TECHNICAL REPORT

PARTS CHANGES (VOL. 28)

NO. C-711

MODEL. CS,QS,EL,PC,CE

6 & 7. Structural change

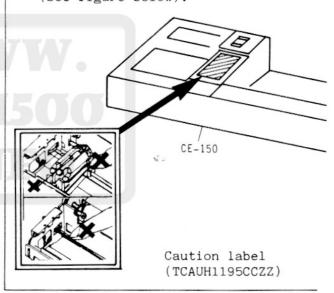
In order to attain shared use with those of other models, a change is made for the structure of battery terminal which is connecting to the LSI.

15. Structural change

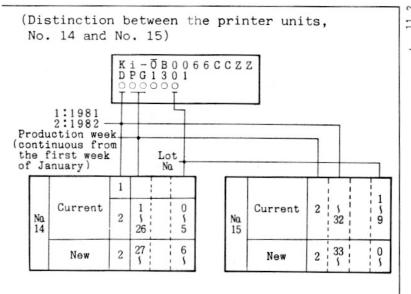
In order to attain shared use of the parts with those of other models, change is met in the structure of the bobbin gear.
